CABINET MEMBER FOR ENVIRONMENT – 17 SEPTEMBER 2020

BLOXHAM – PROPOSED EXTENSION OF 30MPH SPEED LIMIT AT A361 BANBURY ROAD & BLOXHAM GROVE ROAD

Report by Interim Director of Community Operations

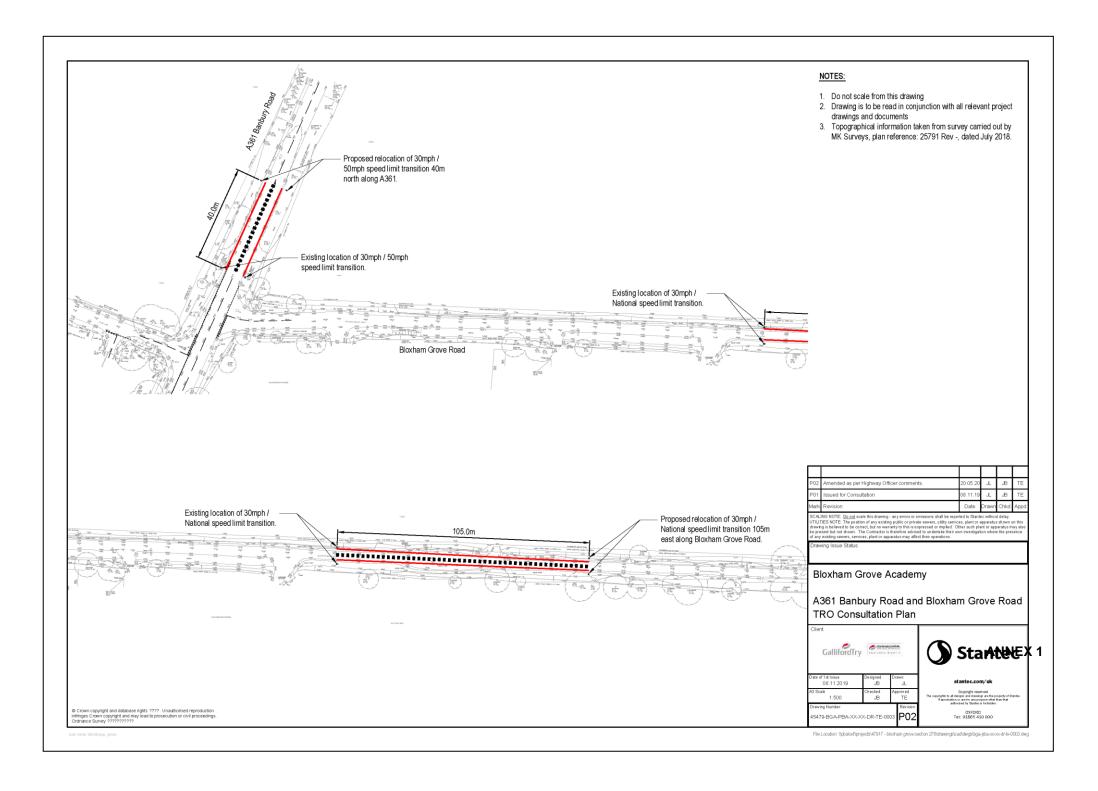
| RESPONDENT | SUMMARISED COMMENTS |
|--|--|
| (1) Traffic Management Officer, (Thames Valley Police) | No objection – The new development will move the village urban character south and the revised plan for the 30mph limit appears appropriate. My concern will be with access construction and the school adjacent to Bloxham Grove Road and road safety with parking and congestion potentials. Are any planning consent mitigation measures in place? |
| (2) Bloxham Parish Council | A361 Bloxham Road 30mph Speed Limit - Object Bloxham Grove Road 30mph Speed Limit - Support The speed limit on the A361 not be reduced from 50mph to 30mph but from 50mph to 40mph, until the limit reduces to 30mph anyway as the A361 enters Bloxham. The 30mph speed limit to Warriner School along Bloxham Grove Road be supported, but further traffic calming measures are required all the way along Bloxham Grove Road. Consideration could also be given to making the entrance to Bloxham Grove Road 'no entry & access only', especially given the increase in traffic which will arise from the new SEN School. |
| (3) Planning Department, (Cherwell District Council) | No objection – In relation to the works to extend the speed limit on the A361 and Bloxham Grove Road the Planning Department note that these are required in connection with the proposed new school. It is noted that a number of additional highway works are required to be undertaken for the new school which do not form part of the current consultation, but it is assumed that these changes will be consulted upon separately. |
| (4) Local School (Banbury) | A361 Bloxham Road 30mph Speed Limit - Support Bloxham Grove Road 30mph Speed Limit - Support Tudor Hall School notes and supports the plan to close a section of the existing A361 carriageway when the new |

| | roundabout to the Wykham Farm Site is opened. The School notes that a section of the existing grass verge, which has been maintained by the School for over twenty years, will become a carriageway. The School will wish to be consulted about detailed plans to re-instate the remaining part of the verge and will put in an application for a school sign on the remaining verge. |
| (5) Online Response (Banbury) | A361 Bloxham Road 30mph Speed Limit - Support Bloxham Grove Road 30mph Speed Limit - Support Lack of clarity about the way traffic disruption will be handled during a building programme which is fundamentally unnecessary and economically non-viable in the new emerging economic circumstances |
| (6) Individual (Manchester) | A361 Bloxham Road 30mph Speed Limit - Object Bloxham Grove Road 30mph Speed Limit - Object Councils need to stop reducing speed limits every time an accident happens. I am a driving instructor and I'm all for road safety, but reducing limits isn't the answer |

- 7. Thames Valley Police did not object to the proposed speed limits but did note a concern in respect of both road safety and congestion with access construction and parking in Bloxham Grove Road. That will be forwarded to the relevant teams within the County Council for their consideration.

- 9. The comments of the parish council on the A361 speed limit changes which also include the proposed changes on the A361 within Banbury which were consulted on at the same time are noted, but it is considered that the speed limits are consistent with Department for Transport guidance on setting speed limits. Their request for measures on Bloxham Grove Road will also be forwarded to the relevant teams within the County Council for their consideration.

- 10. Cherwell District Council did not object to the proposed extension of the 30mph speed limit on the A361 and Bloxham Grove Road but noted that a number of additional highway works were required to be undertaken for the new school which did not form part of the current consultation, but it is assumed that these changes will be consulted upon separately.

- 11. An objection was received from a member of the public, not a resident of Oxfordshire, to both the proposed speed limit reductions; this objection appeared to be generic and did not reference any local considerations.
